**Daniel J. MacDonald Modernization**

.1 The following Drawings are revised and re-issued with this addendum. Revisions are shown in bubbled areas on drawings. The following descriptions of revisions are for convenience only and do not define or limit the extent of actual revisions indicated on drawings:

End of NORR Addendum No. 7

1 PENTHOUSE FLOOR MECHANICAL RISER DETAILS  
M60-01 SCALE: 1:50

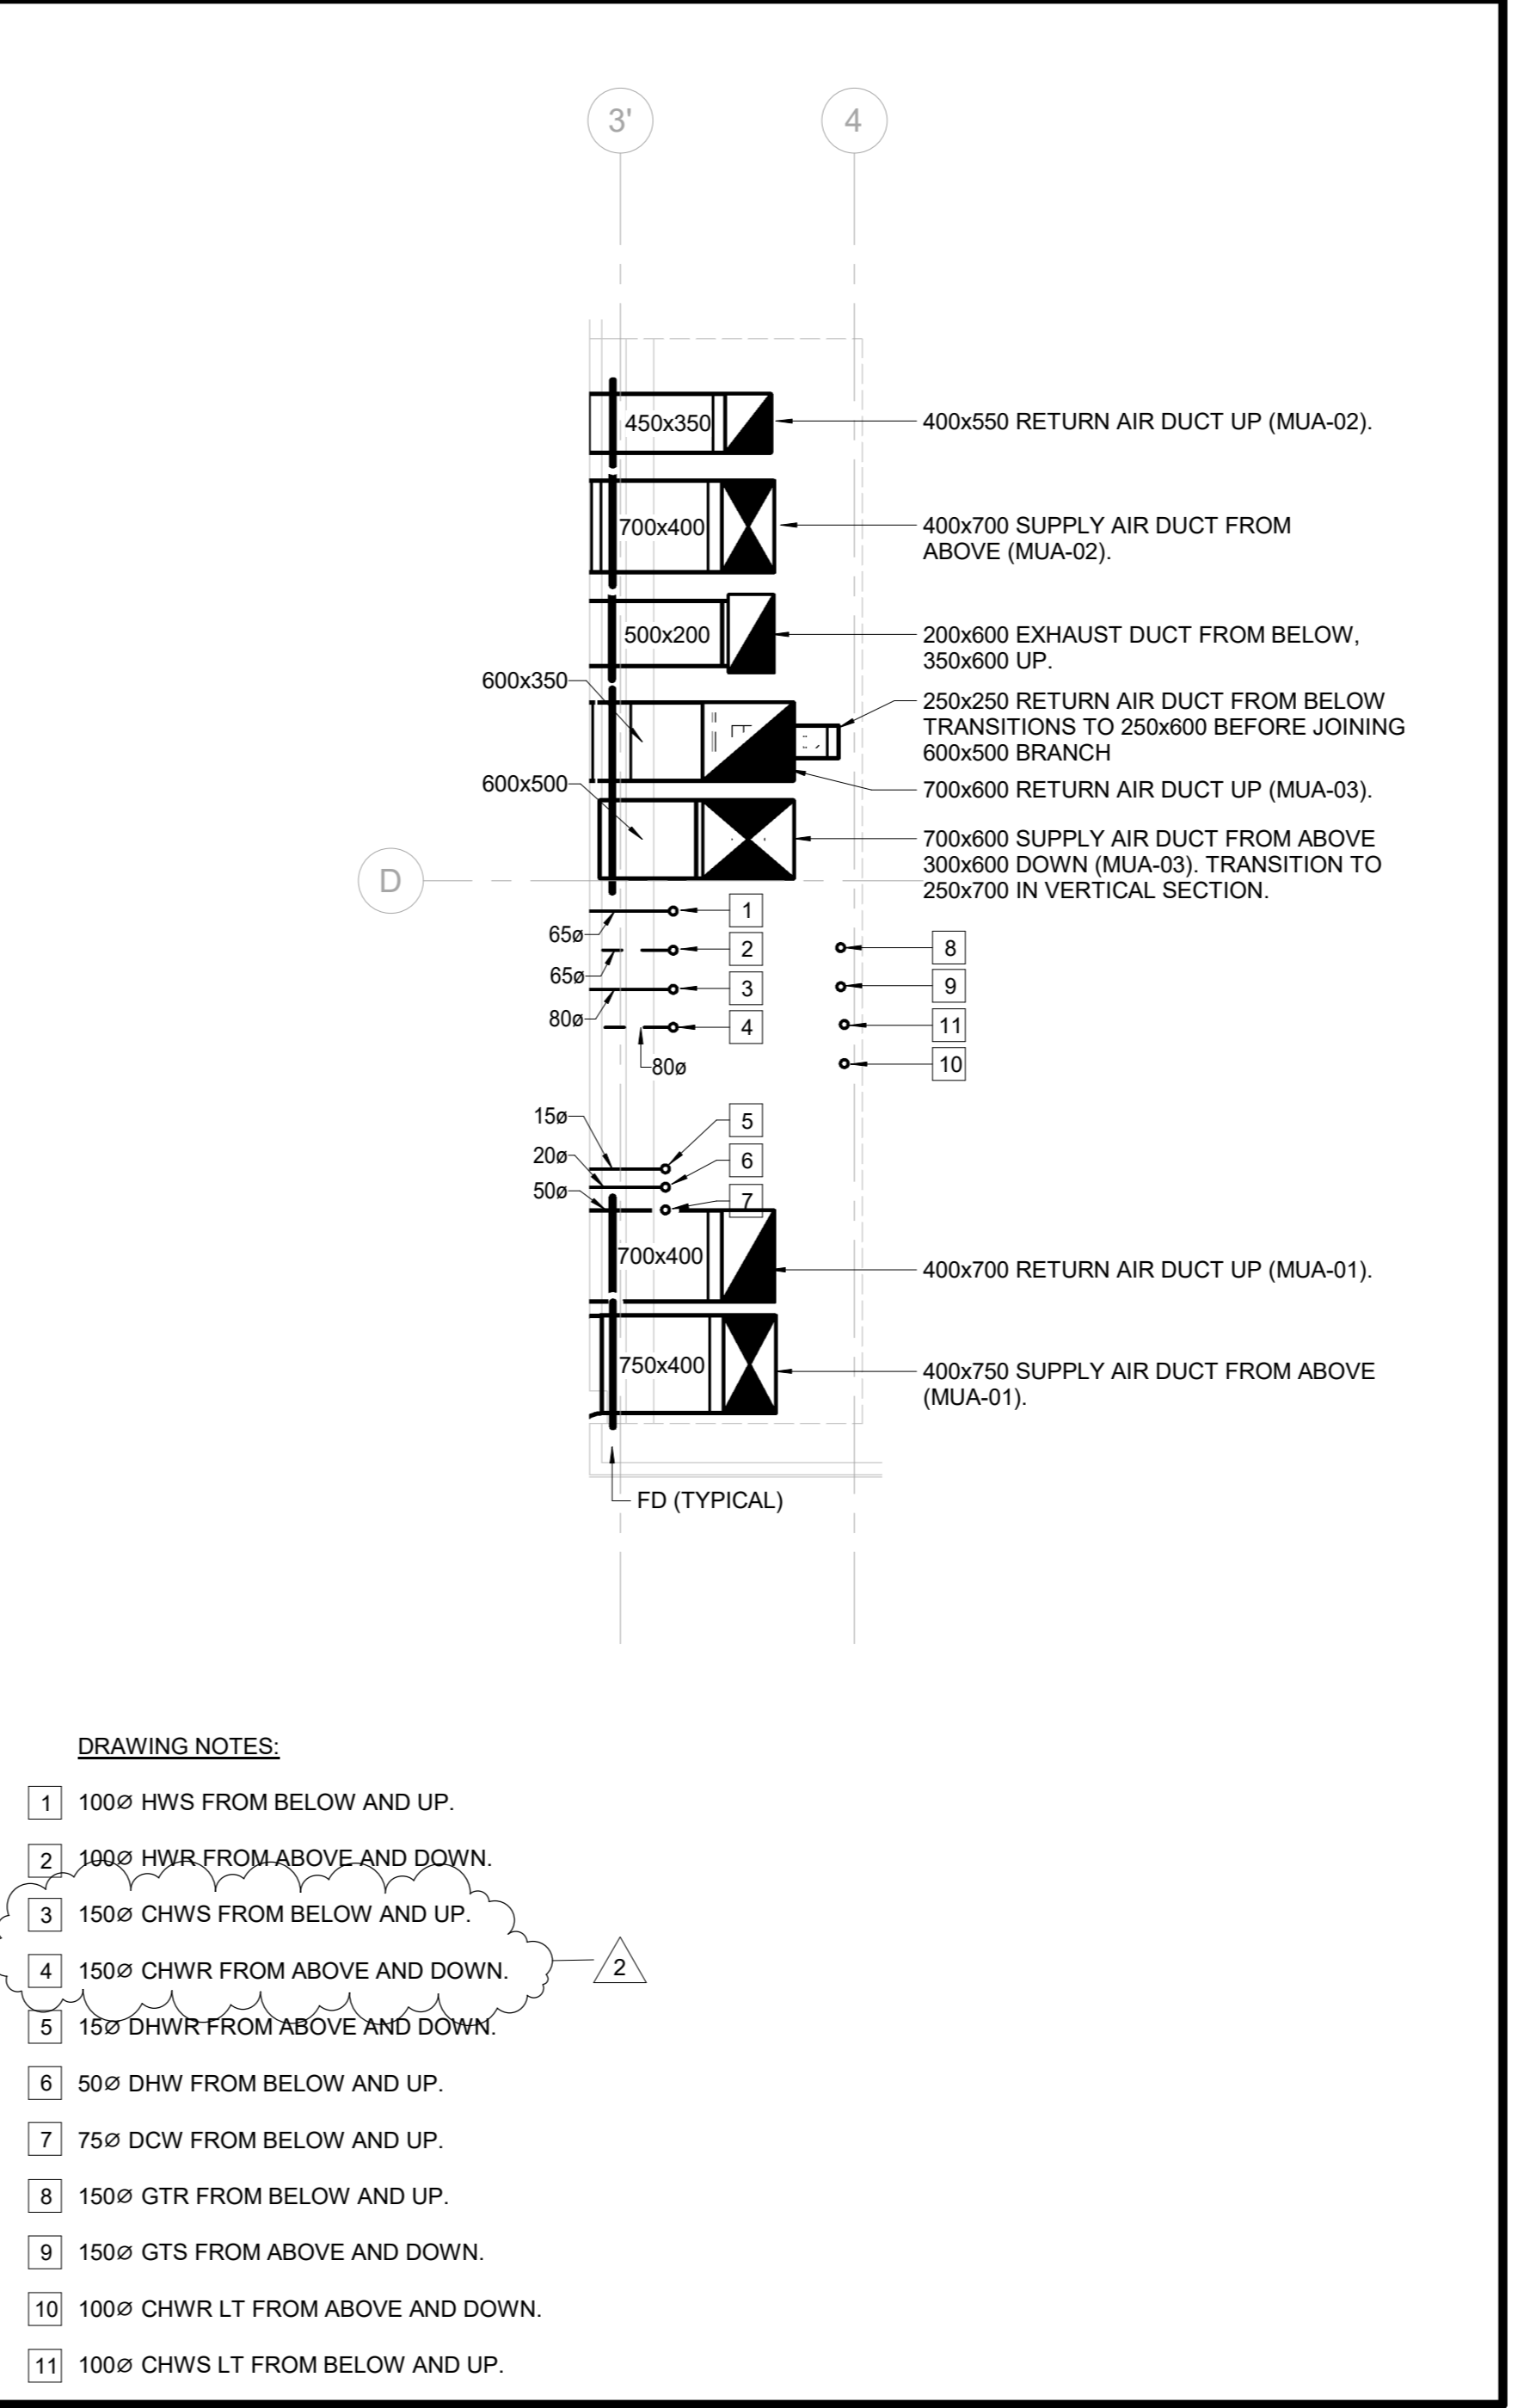
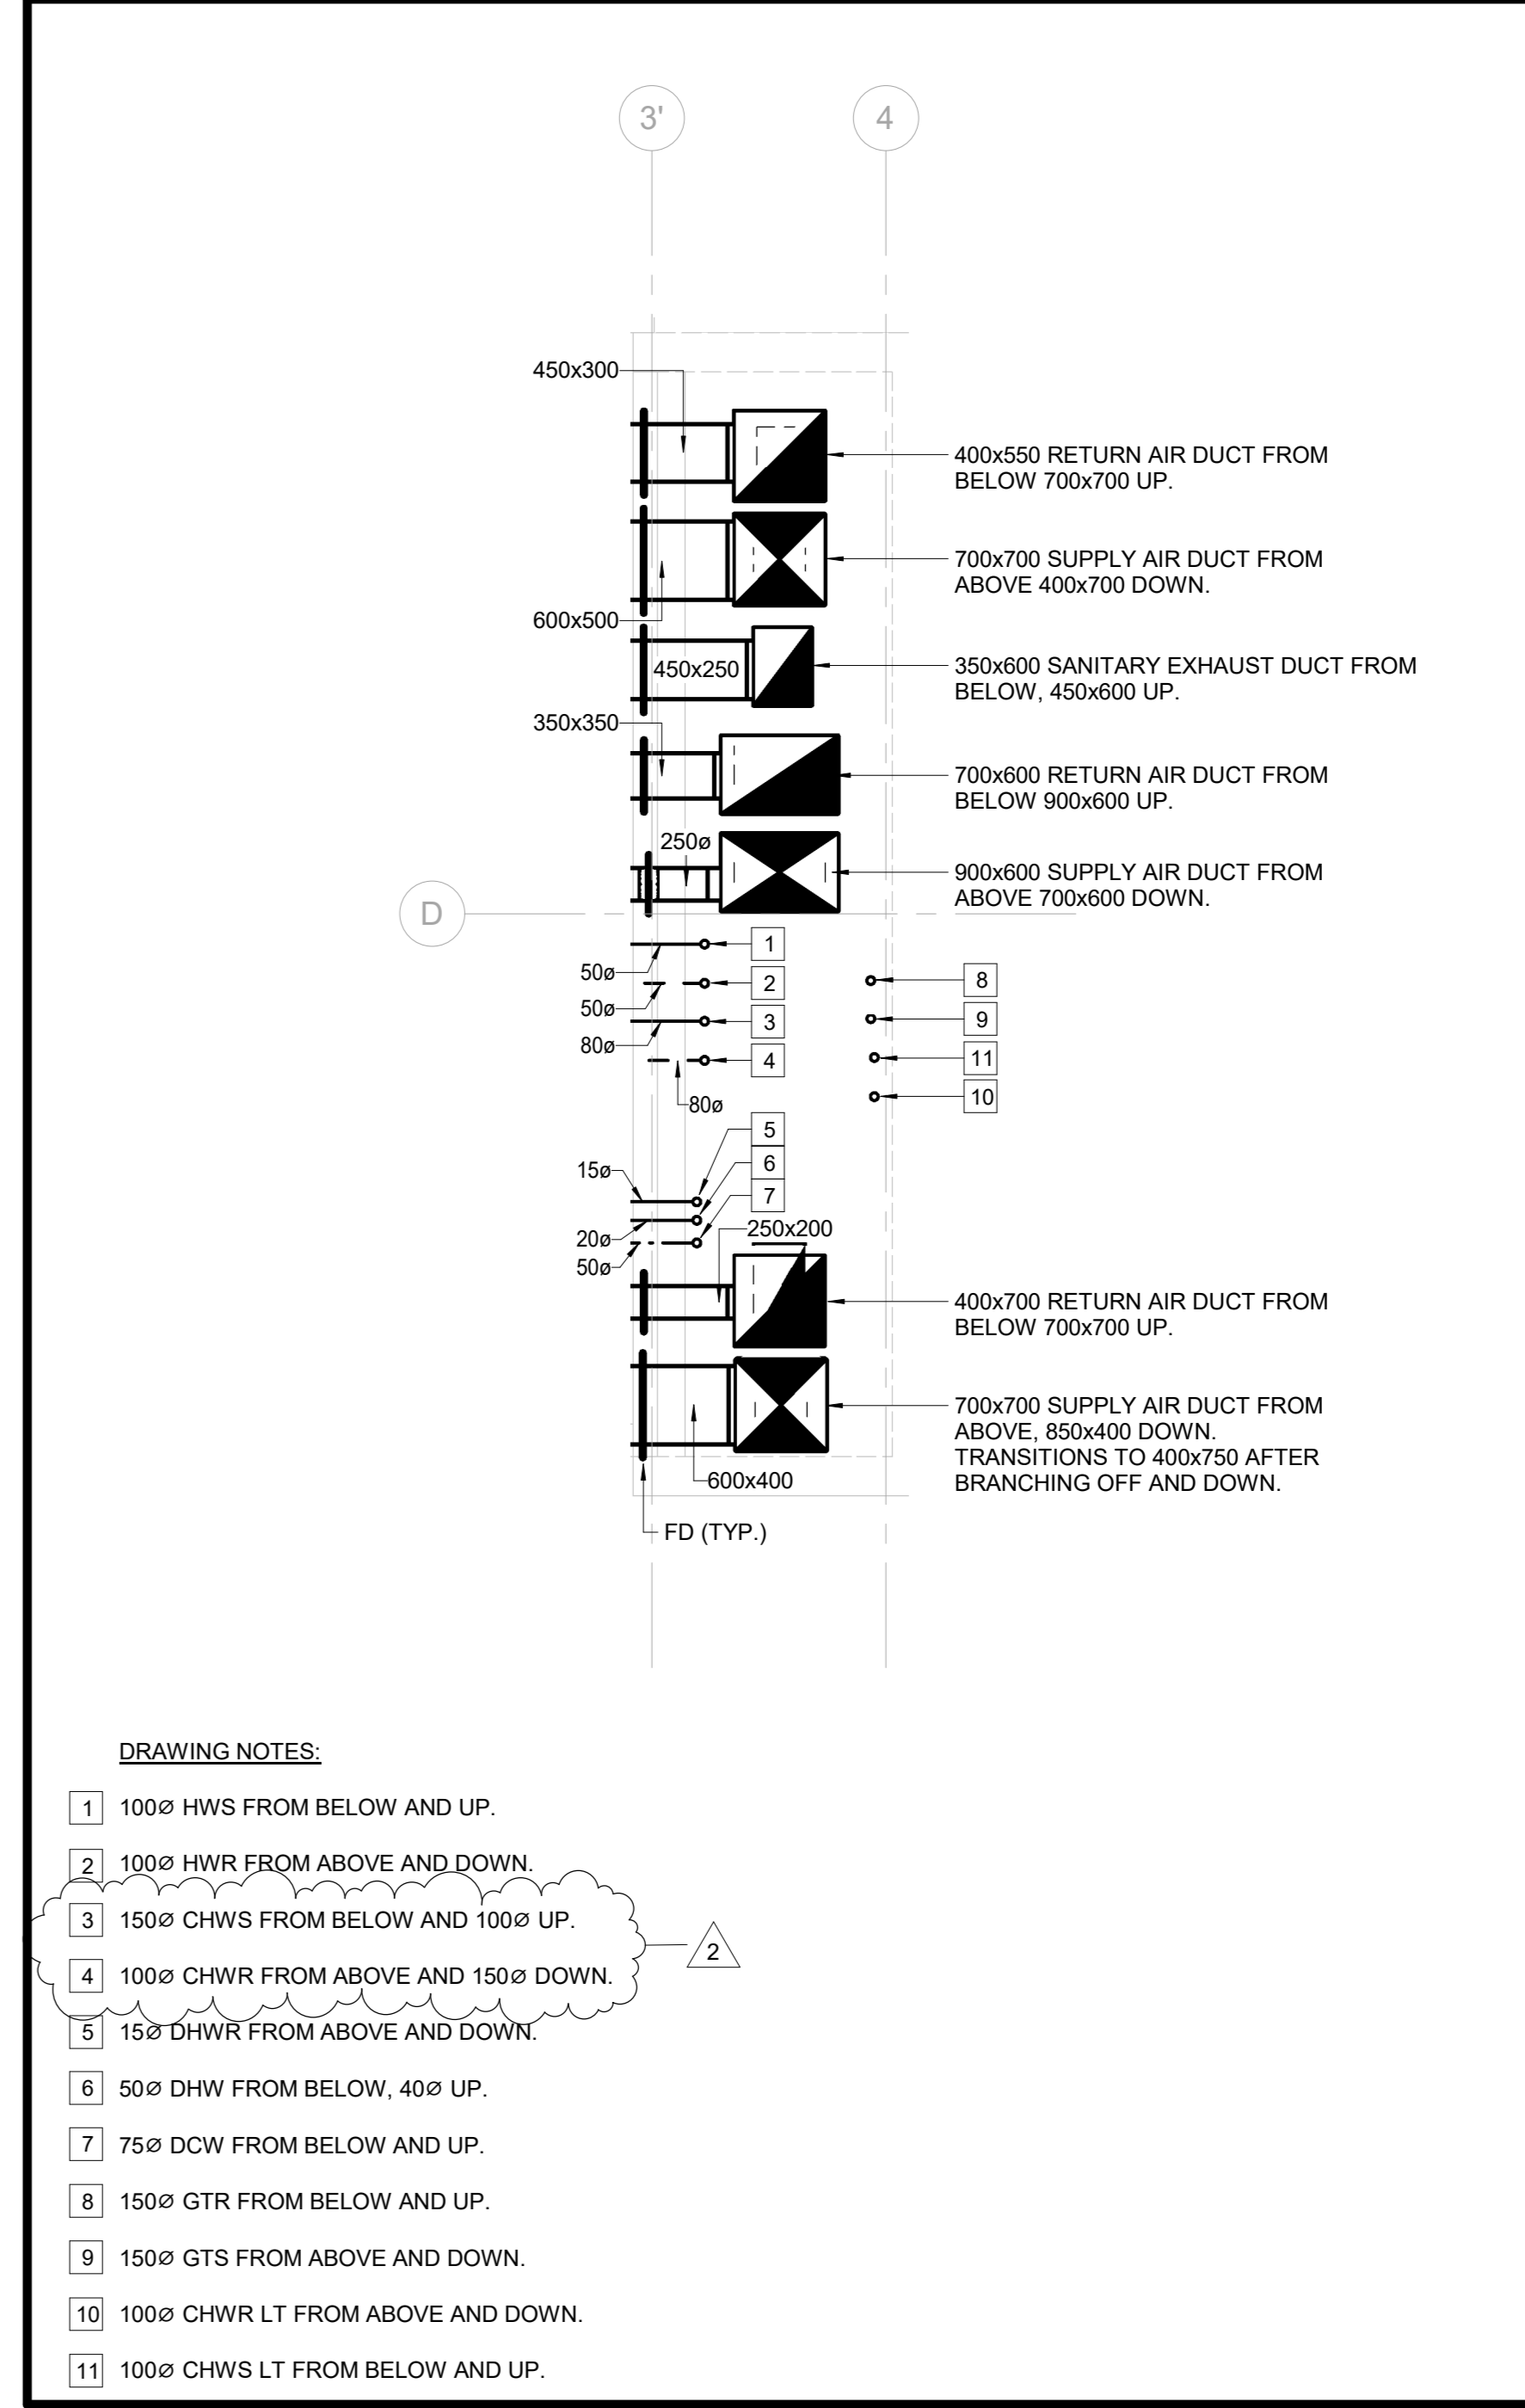
- .8 Drawing M53-06 - HYDRONIC - PENTHOUSE FLOOR NEW WORK
  - .1 Revised pipe sizes.
- .9 Drawing M60-01 - MECHANICAL RISER DETAILS PART PLANS
  - .1 Revised notes reflecting pipe sizes.

**MECHANICAL EQUIPMENT CONNECTIONS SCHEDULE**

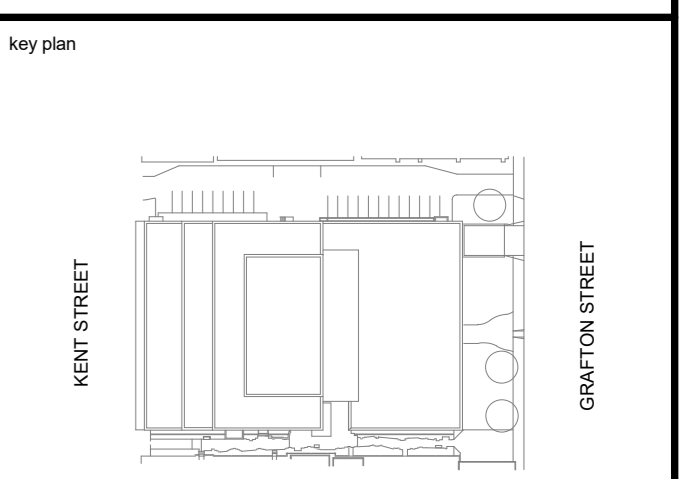
- .11 Drawing E03-03 Electrical Details – Mechanical
  - .1 Mechanical Equipment Connections Schedule revised as shown on the drawing. Revised equipment - Pumps P-23A, P-23B, P-12A, P-12B, P-14A, P-14B, P-14C, P-16A, P-16B, EF-3.
- .12 Drawing E04-01 Single Line Diagram – Normal Power
  - .1 Connections to mechanical equipment revised as shown on the drawing.
